APPLICATION NUMBER: 25/0197

PROPOSAL: CONVERSION OF UPPER FLOORS FROM RENTAL ROOMS ASSOCIATED WITH THE HOTEL TO CREATE 7NO. FLATS AND COMMUNITY FACILITY (D1) AT GROUND FLOOR (RESUBMISSION FOLLOWING REFUSAL OF 23/0703)

SITE: West Of England Hotel 42 Mill Parade Newport NP20 2JS

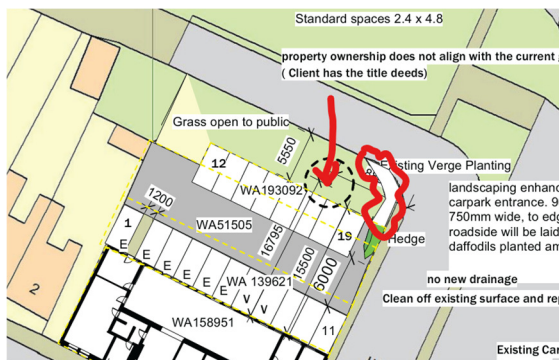
3. A check will be needed on whether a beech hedge maintained to 900mm height is compatible with Highways visibility splay requirements given there is also a highway footpath.
4. The topsoil depth specified below is inadequate for ivy and bulbs at 75mm depth and bulbs at 7 per meter is inadequate, this requires revision.
